## **TLE9260...63(-3)QX(V33) MR-SBC Family**

TLE9263-3QX-Data-Sheet-110-Infineon, Rev 1.1

### **Errata Sheet**

This document lists the errata of the MR-SBC Family related to the Data Sheet, TLE9263-3QX-Data-Sheet-110-Infineon, Rev 1.1.

**Figure 8 Absolute Maximum Ratings for the FO3/TEST Pin**

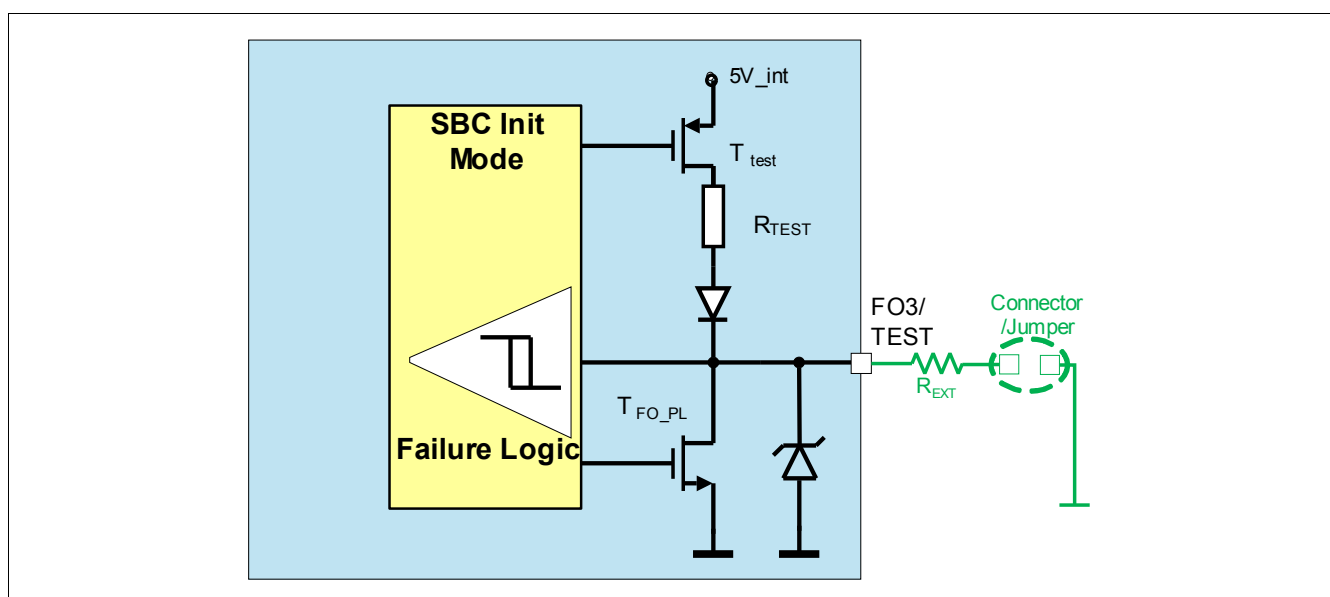
Failure in observing the maximum ratings could result in serious device damage, e.g. due to unprotected handling (ESD risks) or due to a long wire harness of the debugging or programming connector with capacitances in the debugger / programmer.

If this cannot be ensured, e.g. during software debugging in the development phase then a series resistor between FO3/TEST pin and the connector (see **Figure 8**) is recommended to limit the current into or out of the pin.

The value of the series resistor can be calculated by taking the minimum value of the internal pull-up resistor (P\_14.2.5) and the minimum threshold value of FO3/TEST:

A low-level on FO3/TEST can be achieved for resistor values of  $R_{EXT} < 1.3\text{k}\Omega$ . To ensure a safety margin **resistor values of  $100\Omega < R_{EXT} < 470\Omega$  are recommended.**

**Figure 11** Example Oscilloscope Plot Showing the Ripple on the VCC1 Output after a load Jump

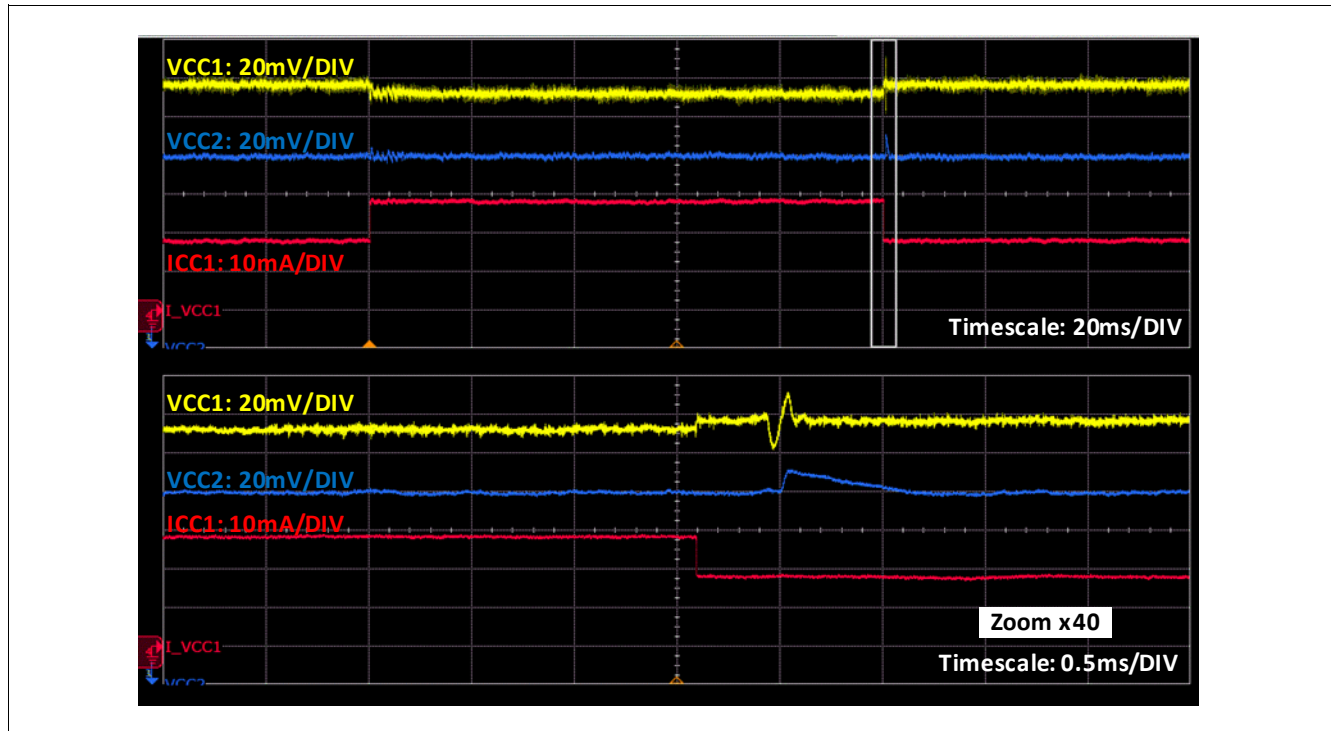
Under certain conditions (described below) a small ripple of ~30mV (peak-peak) can be observed on the VCC1 after a load jump in SBC Init-, Normal-, and Restart Mode (example shown in [Figure 11](#)).

The described ripple on VCC1 is not violating any electrical parameter, i.e. the output voltage is not exceeding the specified +/-2% tolerance. However, the unexpected behavior could disturb voltage measurements, e.g. when VCC1 is used as a ADC reference voltage or during end-of-line voltage calibration.

- The ripple on VCC1 is caused by the switching of the active peak comparator in SBC Init-, Normal-, and Restart Mode. The comparator is used in SBC Stop Mode to switch the regulator from high-current mode (HCM) to low-current mode (LCM) and vice versa. However, the comparator is also enabled in SBC Init-, Normal-, and Restart Mode and will switch when crossing higher (~20mA) load currents (Note: the comparator switching has no functionality in these SBC modes).

- the ripple will only occur at the falling edge of the load jump, i.e. when the load current is falling below the ~20mA range,
- the switching of the active peak comparator applies a load jump on the internal 5V supply and thus a disturbance on it. The voltage regulator reference is derived from the internal 5V supply and therefore this disturbance from the internal 5V supply induces also ripple on the reference voltage which in return causes the ripple on VCC1.

Possible workarounds to avoid an unintended ripple on VCC1 are listed below. The solution is to load the internal 5V supply making it considerably less sensitive to disturbances (e.g. load jumps) and thus minimizing the ripple on VCC1.

**Workaround 1:** Enabling the LIN will stabilize the internal 5V supply and reduce the ripple on the VCC1 output voltage to a minimum.

**Workaround 2:** Enabling the low-side switch function (GPIO functionality) of FO2 or FO3 will also stabilize the internal 5V supply. Set the GPIOs to '110' in GPIO\_CTRL.

**Workaround 3:** Depending on the load jump the ripple can be avoided when the higher active peak threshold  $I_{VCC1,peak2}$  is selected via SPI ( $I\_PEAK\_TH = 1$ ). In this case the ripple will occur only at a load current of factor two (~40mA range). If required for quiescent current reasons, the lower active peak threshold should be selected when entering SBC Stop Mode.
